ATTACHMENT A

EXISTING TECHNICAL SPECIFICATIONS AND BASES
UNIT 3

ATTACHMENT B

PROPOSED TECHNICAL SPECIFICATIONS AND BASES
UNIT 3

FIGURE 3.4-2

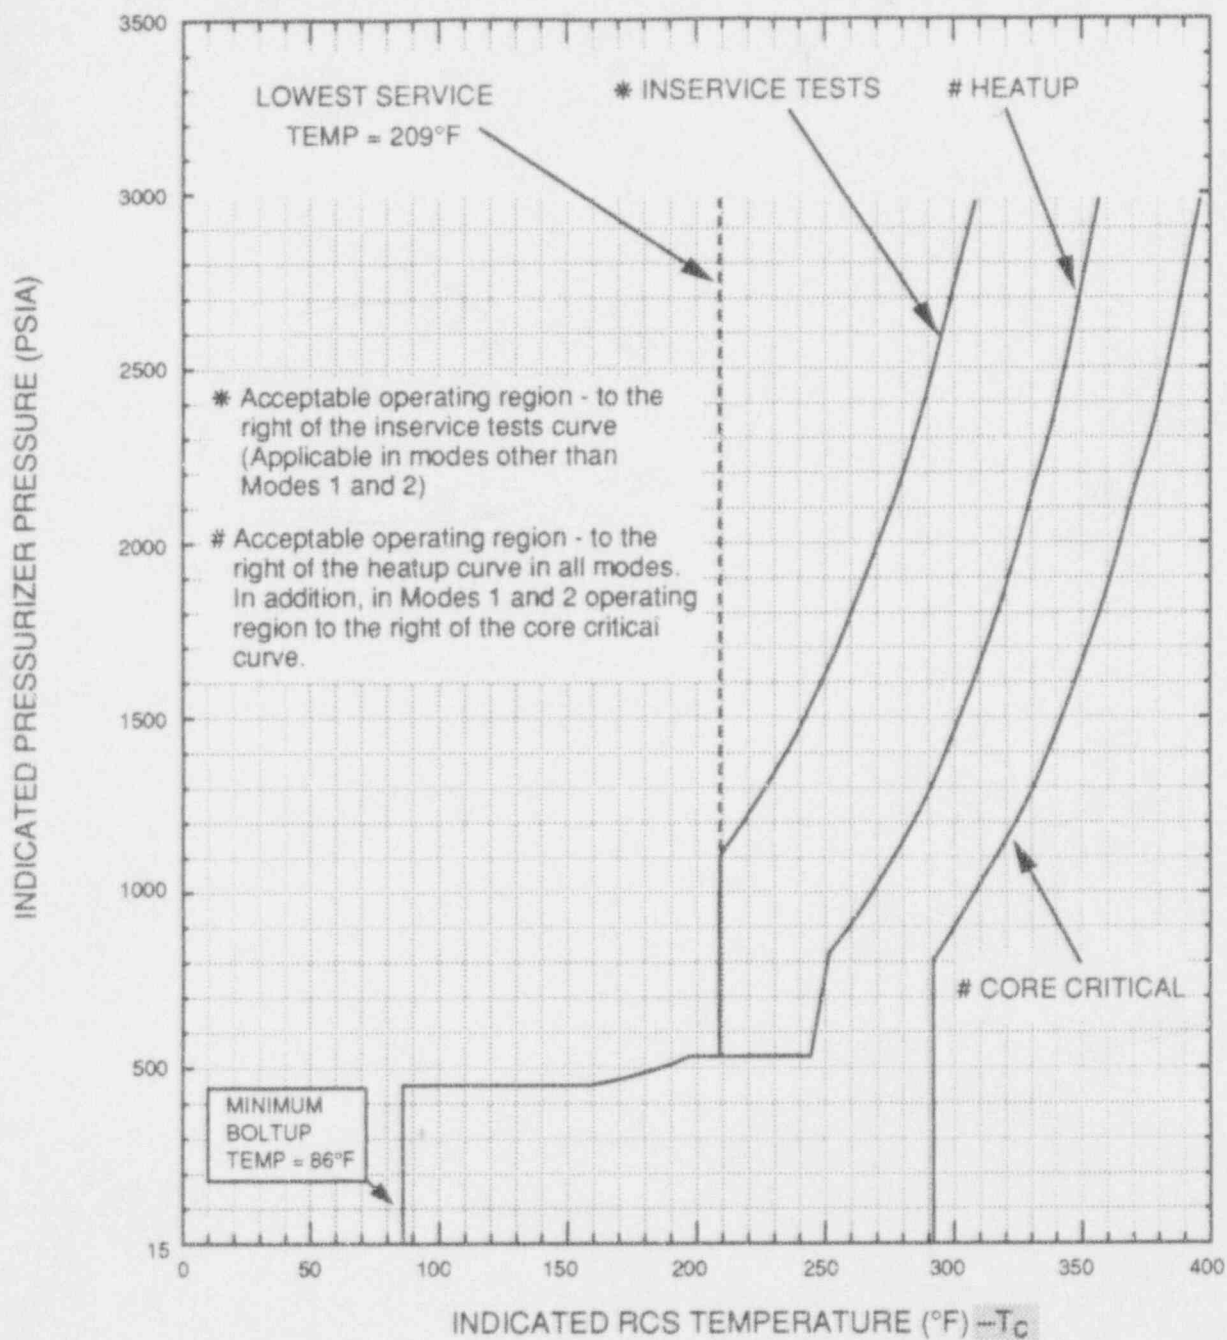
SONGS 3 HEATUP RCS PRESSURE/TEMPERATURE
LIMITATIONS FOR 4— UNTIL 8 EFPY
Normal Operation

FIGURE 3.4-4

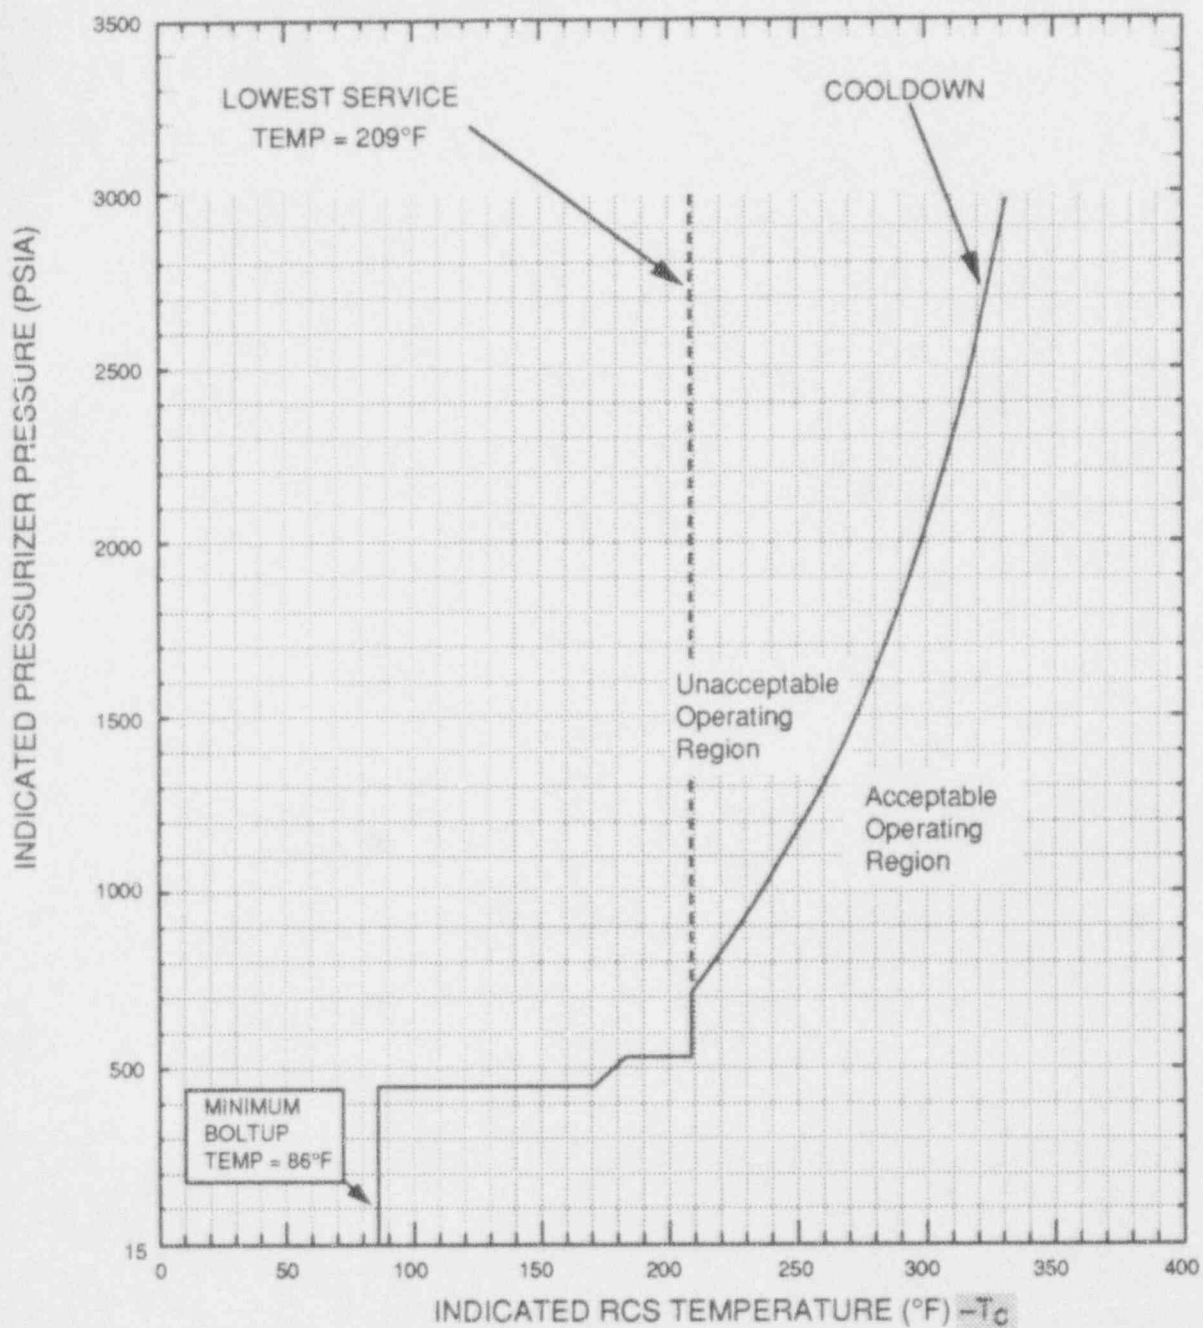
SONGS 3 COOLDOWN RCS PRESSURE/TEMPERATURE
LIMITATIONS FOR 4- UNTIL 8 EFY
Normal Operation

FIGURE 3.4-5

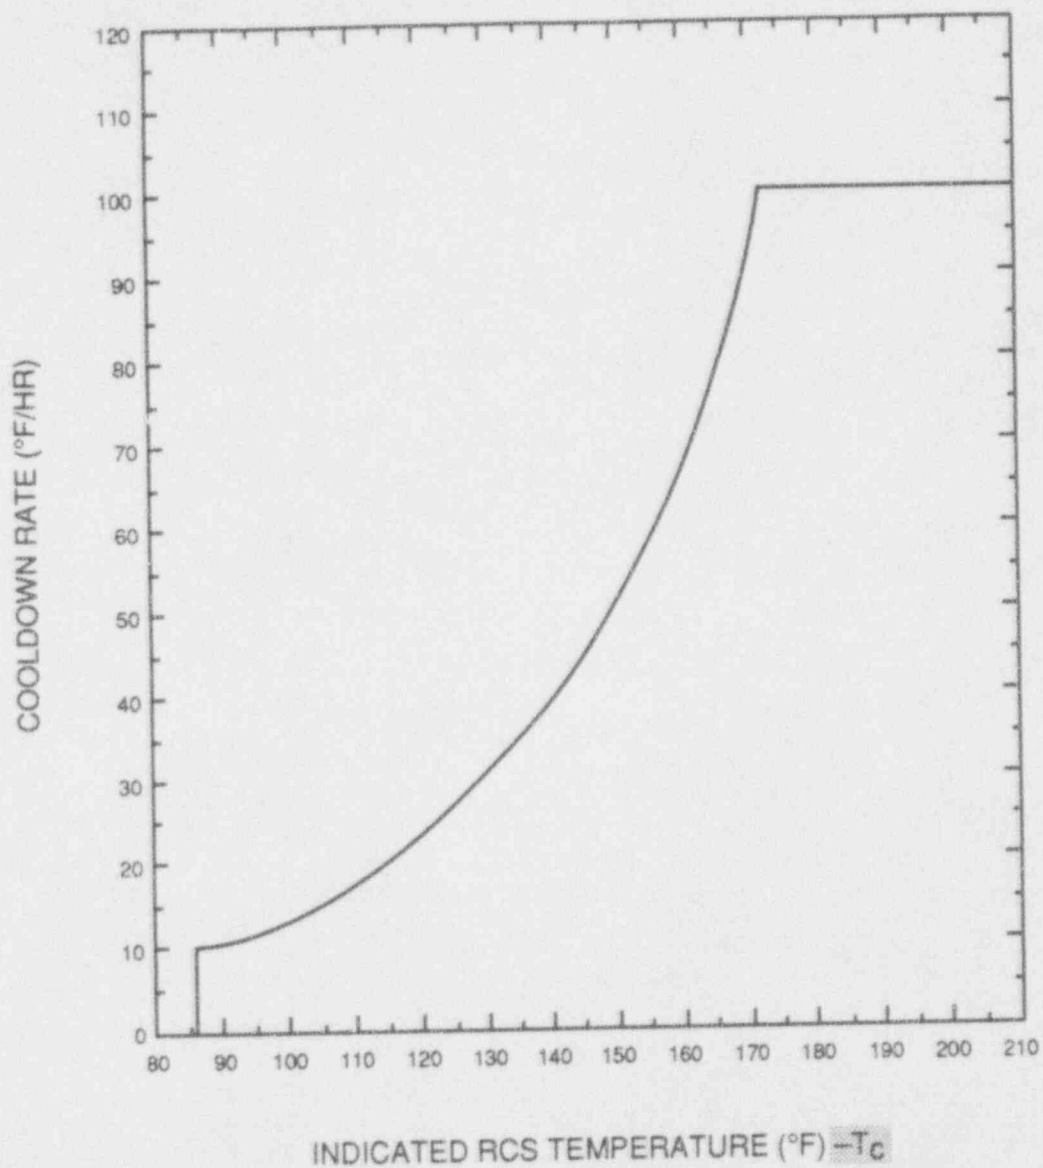
NOTE: A MAXIMUM COOLDOWN RATE OF 100°F/HR IS ALLOWED
AT ANY TEMPERATURE ABOVE 126°F 172°F

SONGS 3 RCS PRESSURE/TEMPERATURE LIMITS
MAXIMUM ALLOWABLE COOLDOWN RATES (—4— UNTIL 8 EFPY)
Normal Operation

FIGURE 3.4-6

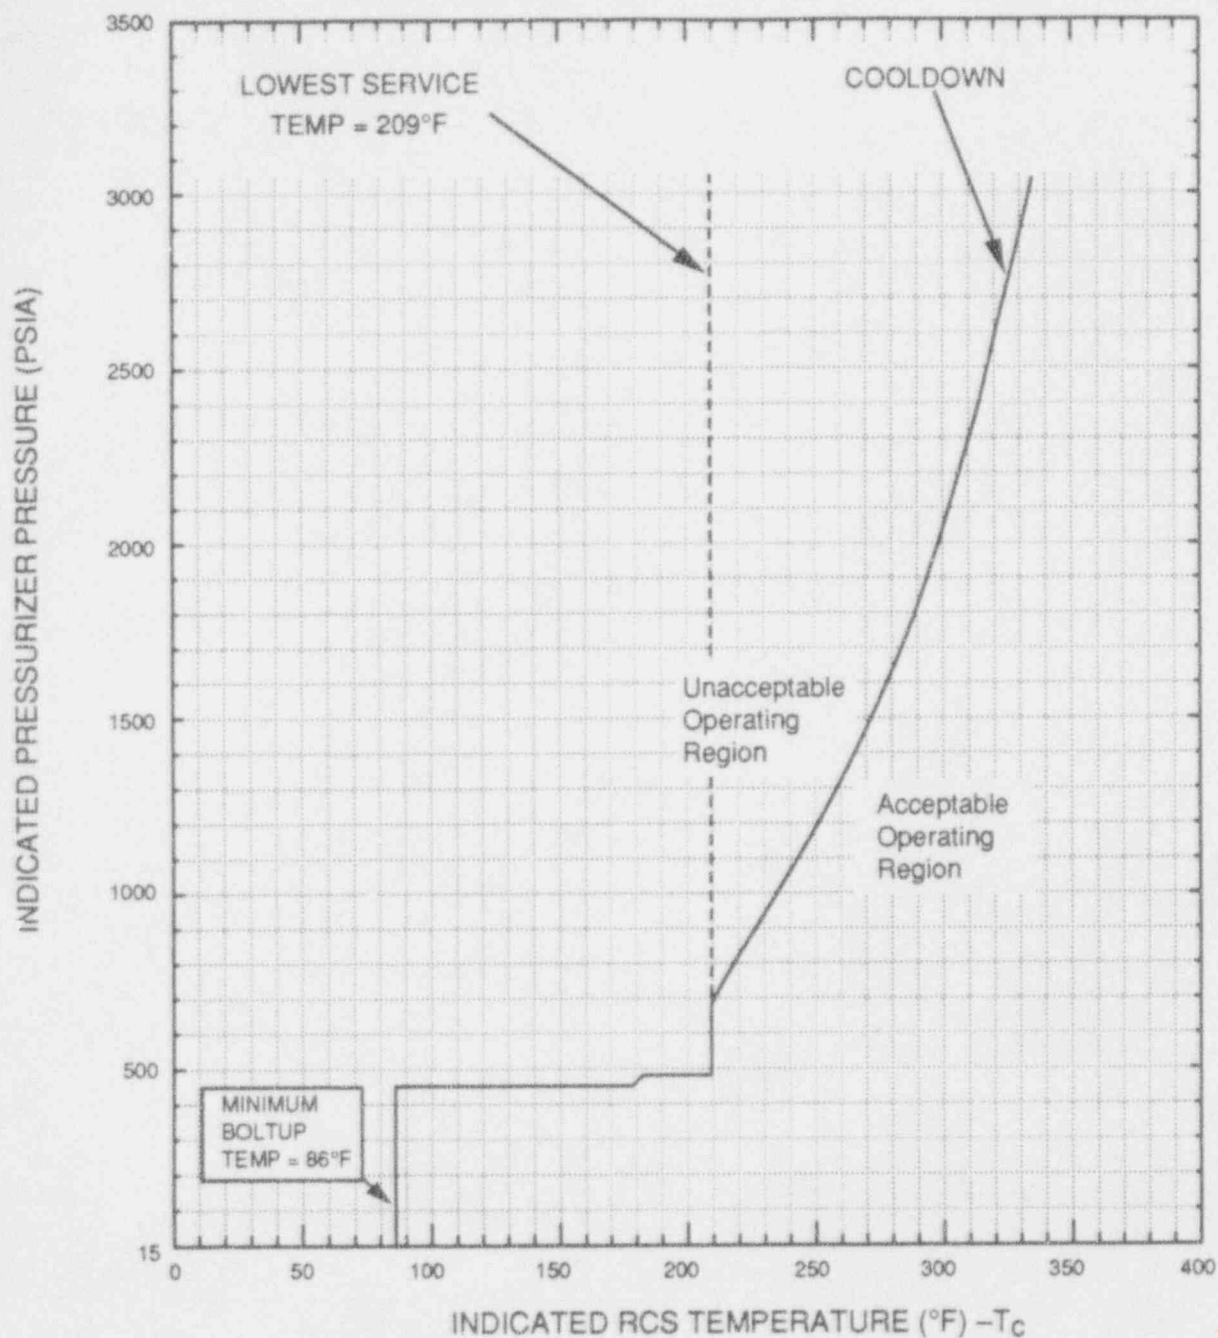
SONGS 3 COOLDOWN RCS PRESSURE/TEMPERATURE
LIMITATIONS UNTIL 8 EFPY
Remote Shutdown Operation

FIGURE 3.4-7

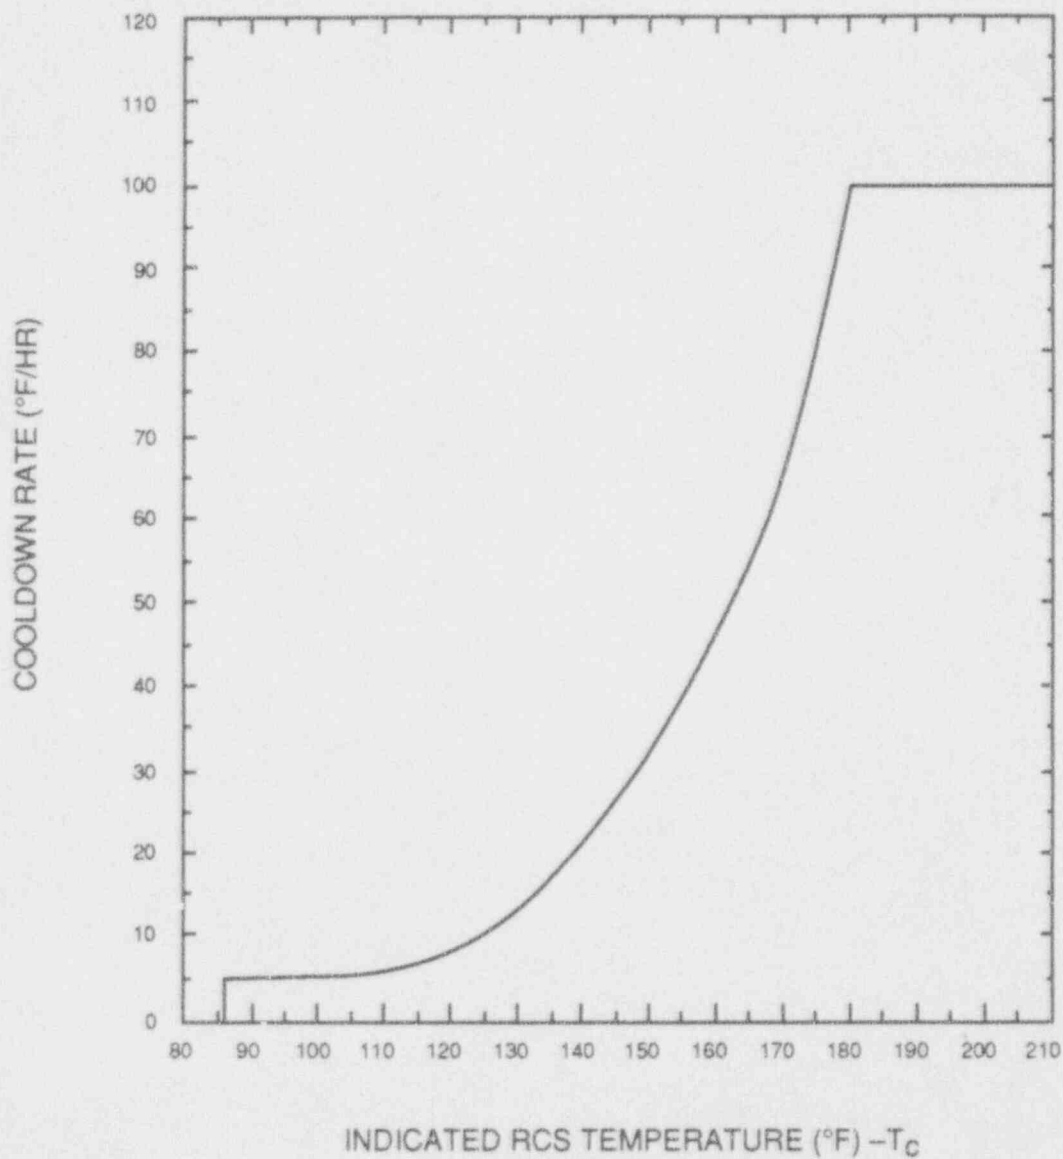
NOTE: A MAXIMUM COOLDOWN RATE OF 100°F/HR IS ALLOWED
AT ANY TEMPERATURE ABOVE 180°F

SONGS 3 RCS PRESSURE/TEMPERATURE LIMITS
MAXIMUM ALLOWABLE COOLDOWN RATES (UNTIL 8 EFY)
Remote Shutdown Operation
